M54 to M6 Link Road

TR010054

8.5 Formal Request for Scheme Changes

October 2020

Drawing Title
**SCHEME CHANGES
DRAWING FOR
THE INSPECTORATE
SHEET 1**

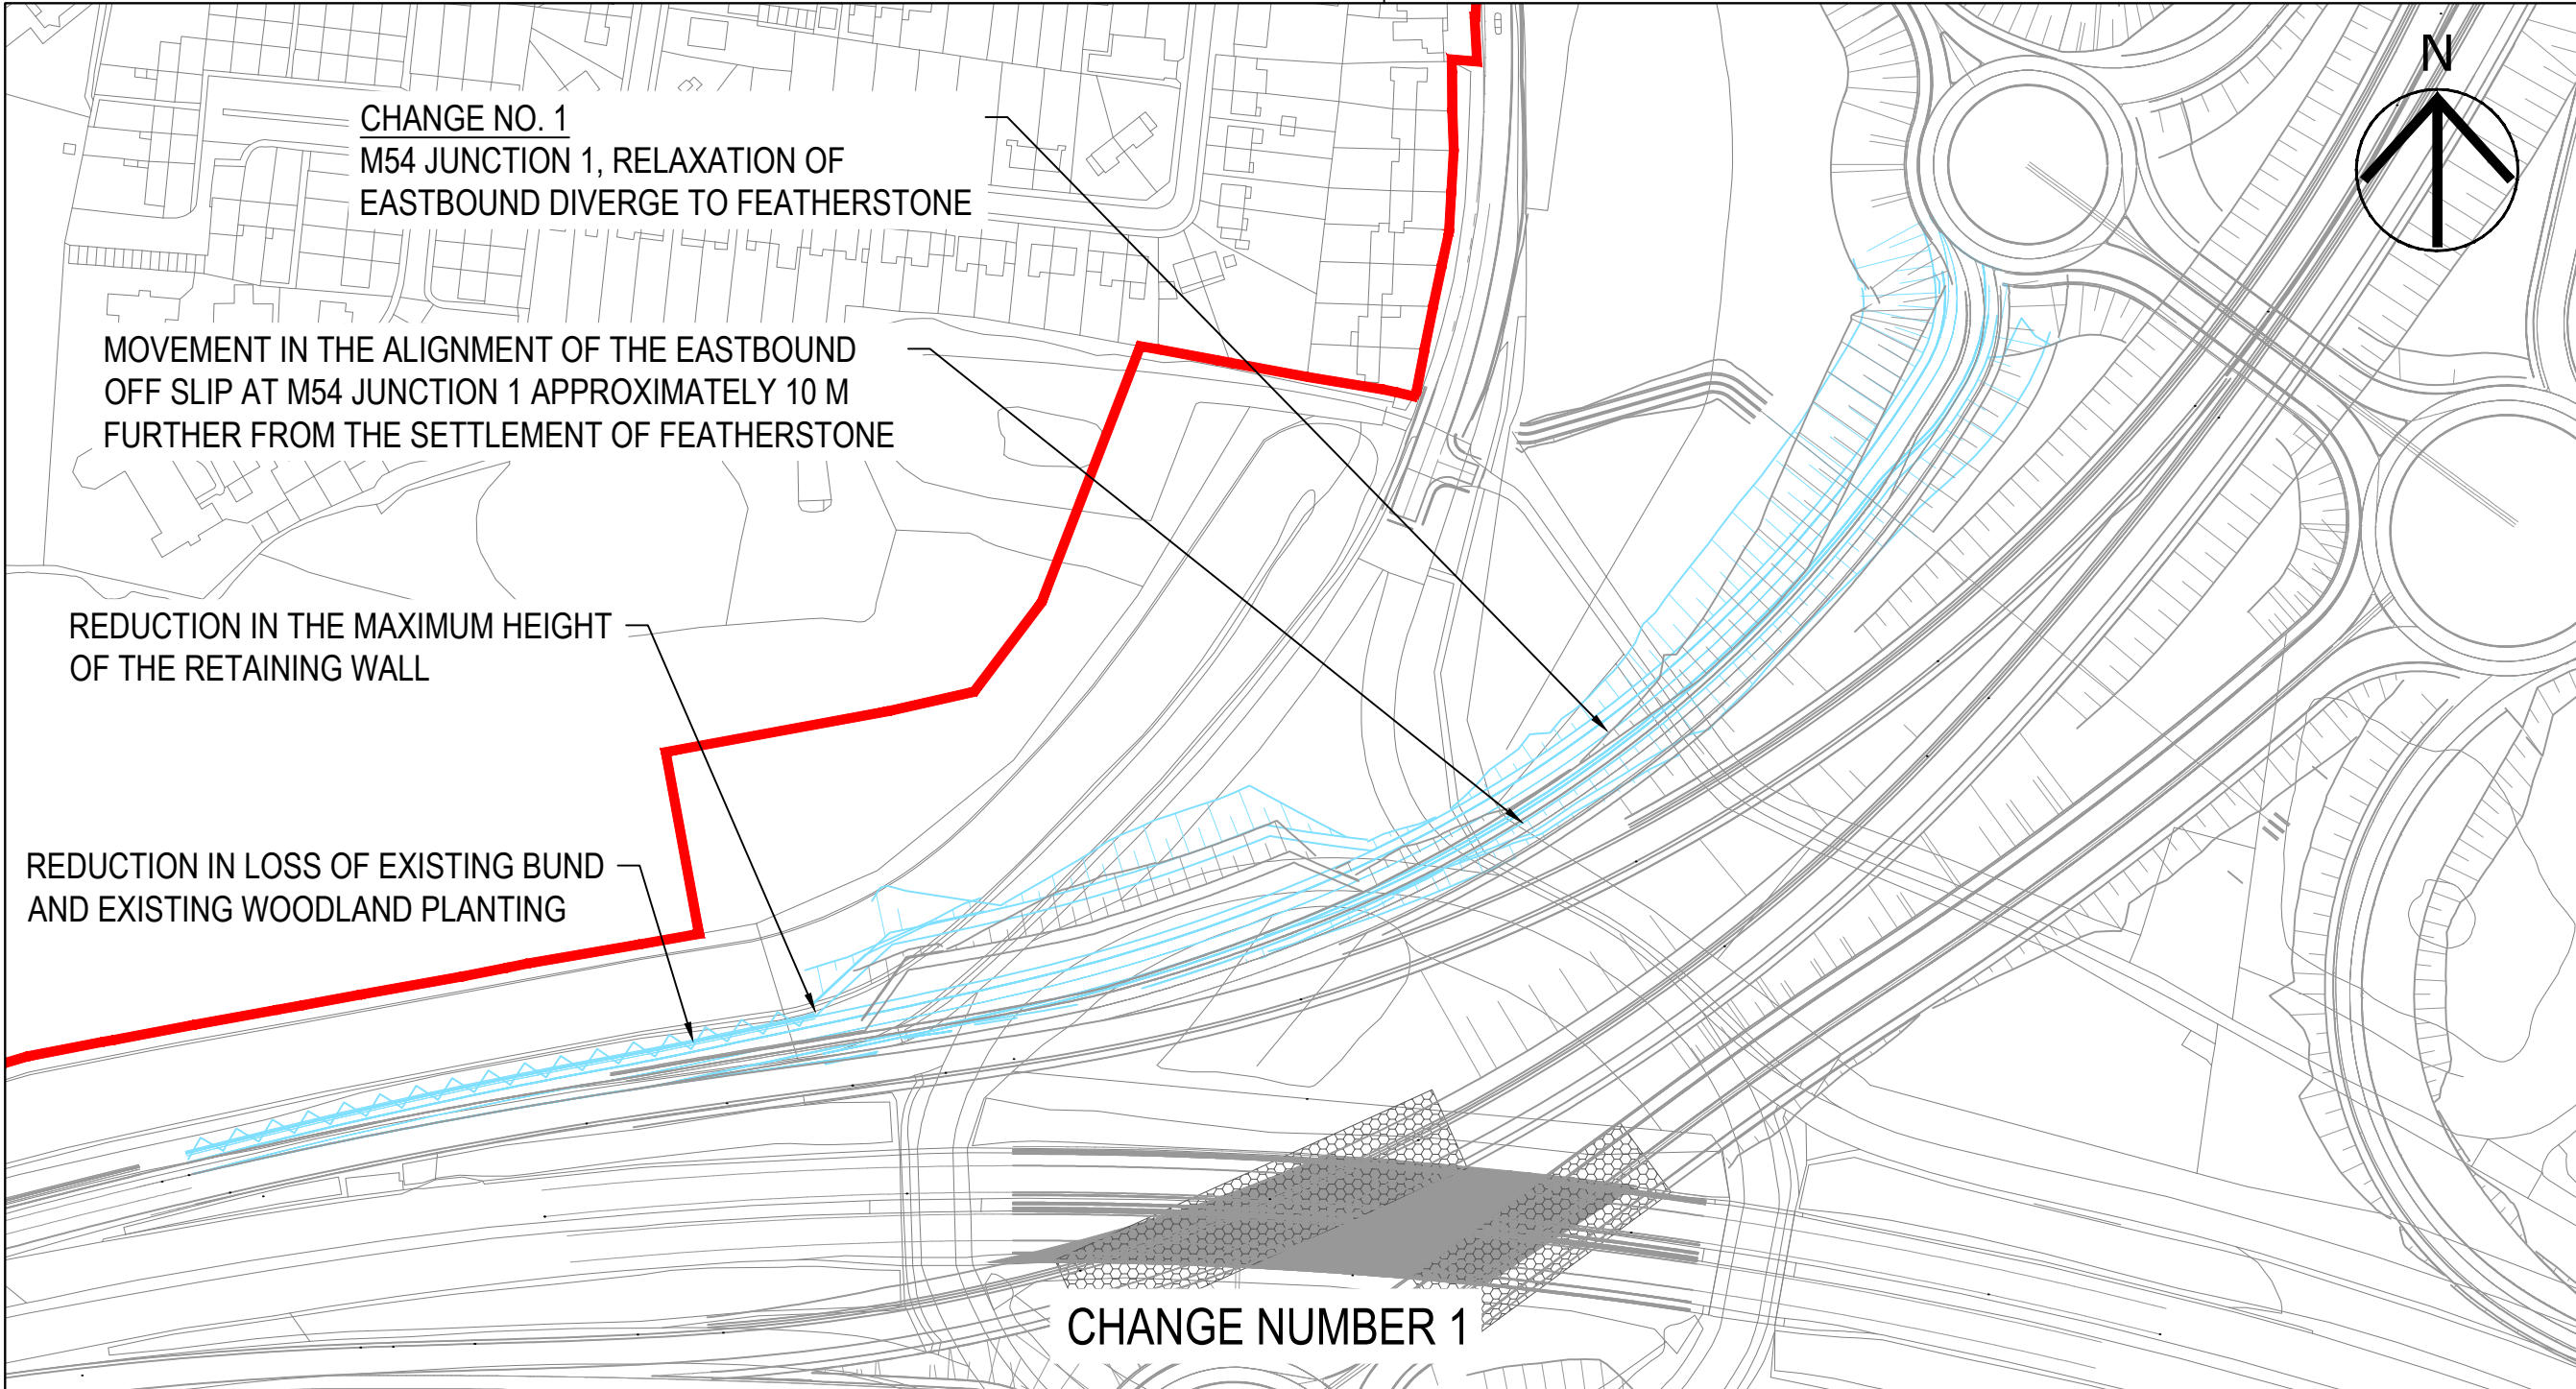
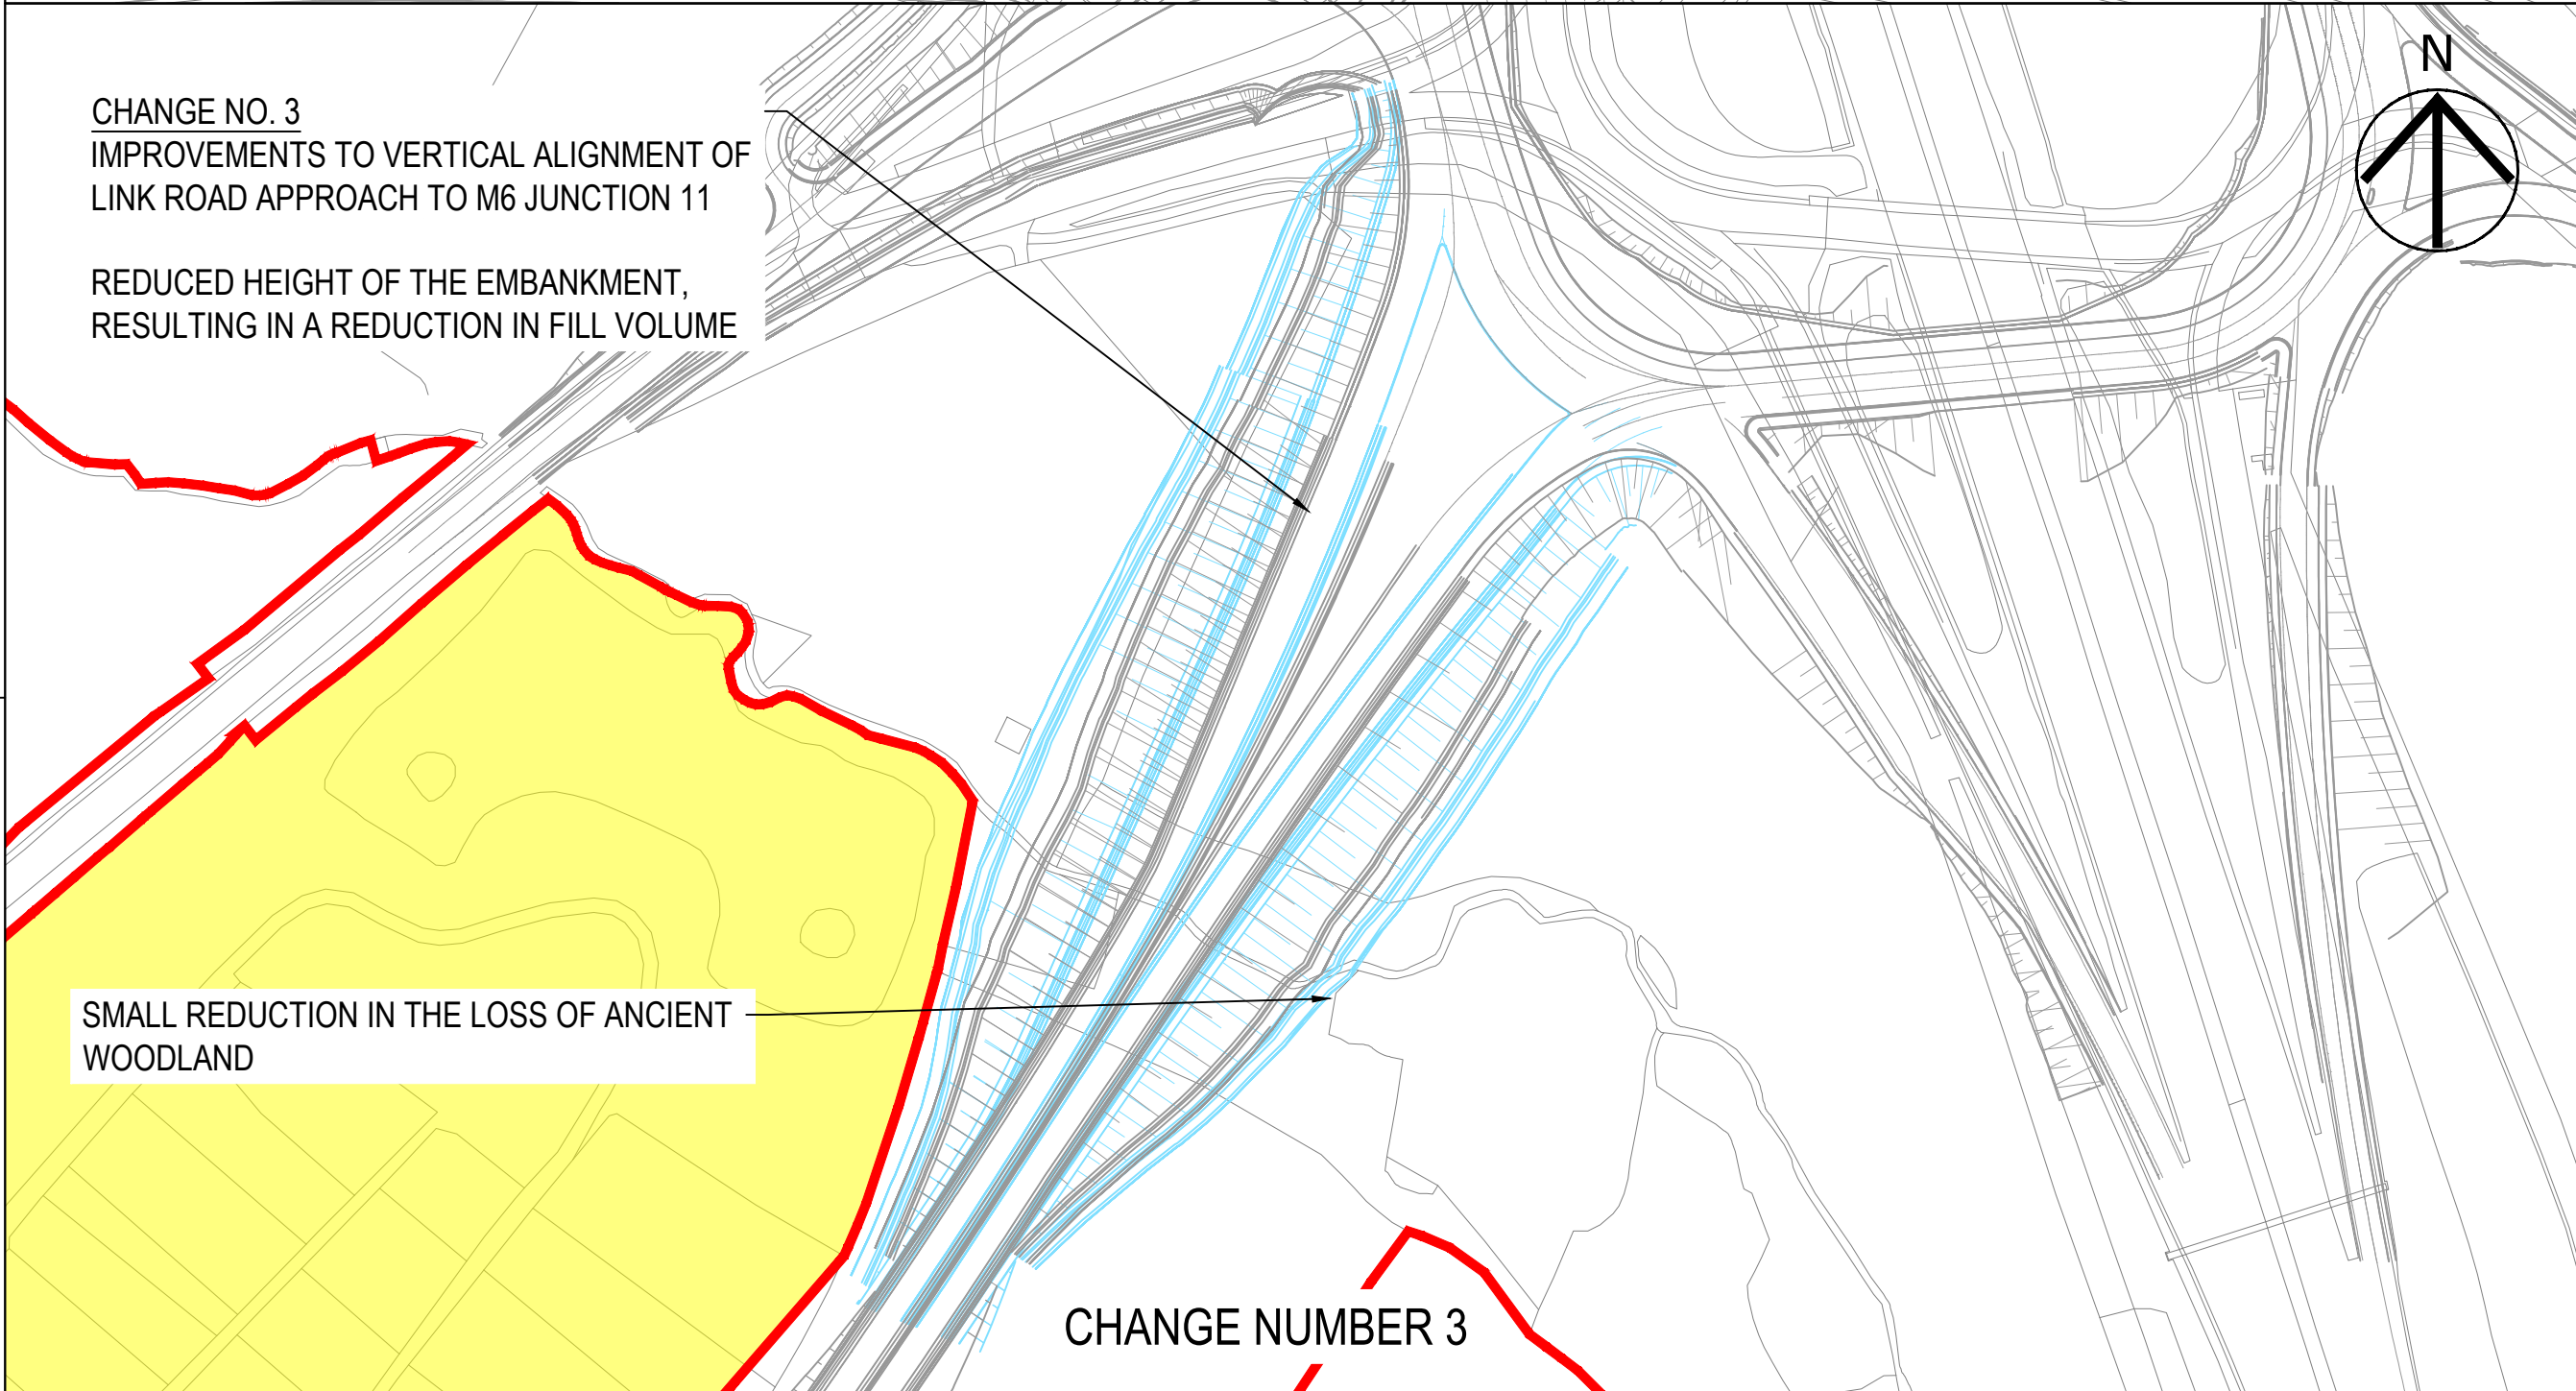
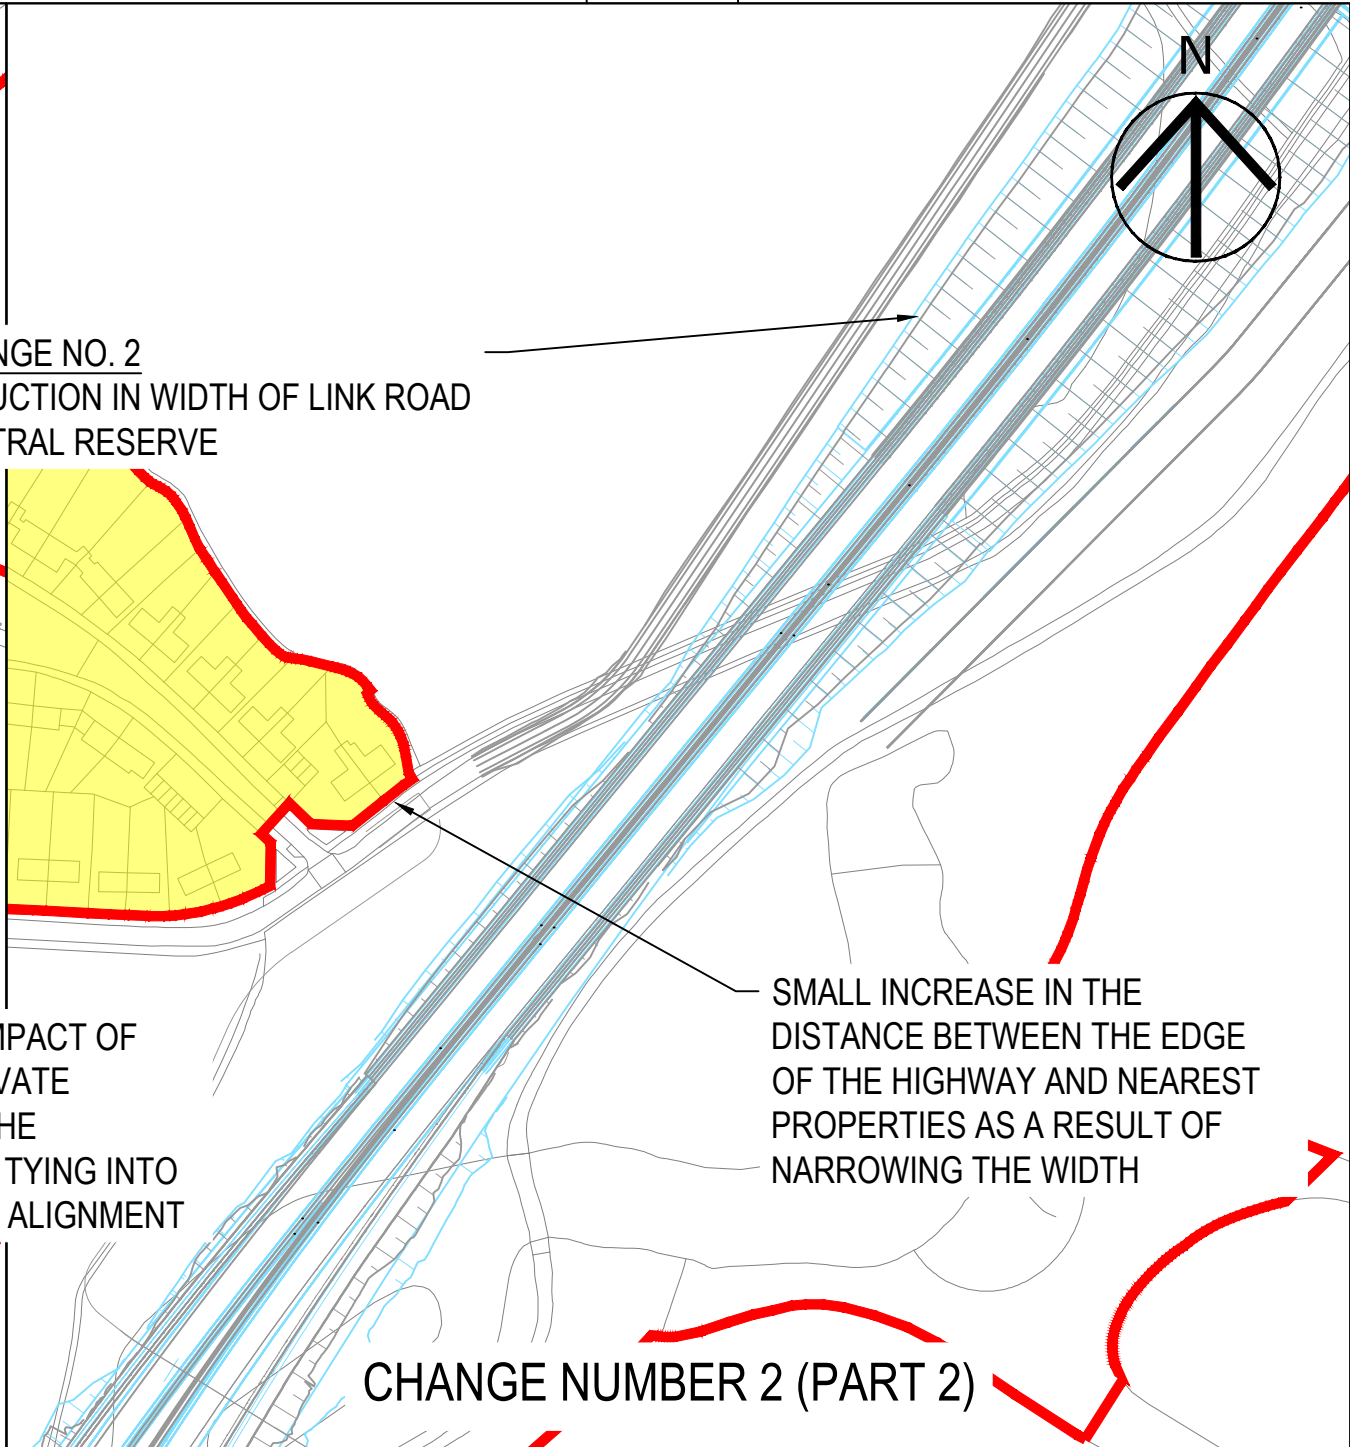
- 2.2.2 This change proposes a minor realignment of the eastbound exit slip road to Featherstone, reducing the length of the slip road to the dumb-bell junction. This will bring the road closer to the junction and reduce the overall size of the junction.

- 2.3.2 This proposed change would reduce the overall width of the link road by reducing the width of the central reserve from 4.5 m to 3 m along the length of the new link road and reducing the width of the verge area by putting the surface water channel in the verge rather than adjacent to it. There would be no reduction to the width of traffic lanes or hard strips.

2.4.2 This change would reduce the height of the approach to M6 Junction 11 by approximately 0.7 m where the road passes through an area of woodland near Latherford Brook. This change would increase the gradient of the approach to the Junction. However, the gradient would be within the recommended design for dual carriageway standard, with a maximum 2% gradient at the stop line to reduce the risk of vehicle roll back. Therefore no safety impact is anticipated as a result of this change. A minor change has also been incorporated to the diversion route of Saredon 8 Public Right of Way as a result of changes to the embankment.

- 2.5.1 To provide free-flow links between the M54 and the new link road, the Scheme included construction of a new bridge to carry the roads through the redesigned M54 Junction 1. The original Scheme would have taken a period of approximately two years to build the bridge in sections at its final location. This would need complex and long-term traffic management for over two years on the M54, over several phases, including contraflows, narrow lanes and lane closures as well as several overnight closures with night-time working. The proposed change utilises an innovative construction solution negating the need for two years of traffic management. It involves constructing the bridge as two simpler structures in a nearby site compound to the north-east of the junction and moving them into position when ready. To do this safely, the change would require the closure of the M54 over Junction 1 and some of the slip roads for up to three weeks. Building the bridge as two simpler structures also enables the movement of the road alignment by 20 m, which will reduce the size of Junction 1.

- 2.6.1 Near Hilton Lane, the new link road will be below existing ground level and Hilton Lane will cross the link road via a new bridge. Following further work to review the Scheme construction methods, it is proposed to build the Hilton Lane bridge to the north of its current proposed location. This change would enable the retention of more of the existing route of the Public Right of Way (PRoW) [Shareshill 5] across nearby land rather than routing it alongside the link road as is currently proposed in the DCO application.

- 2.7.1 This change is proposed to alter the alignment of the slip road between the M54 Junction 1 eastern dumbbell roundabout and the M54 eastbound to the west of the position shown in the original application. This change aims to address concerns raised by the landowner at Tower House Farm that the Scheme will adversely impact access to the site.
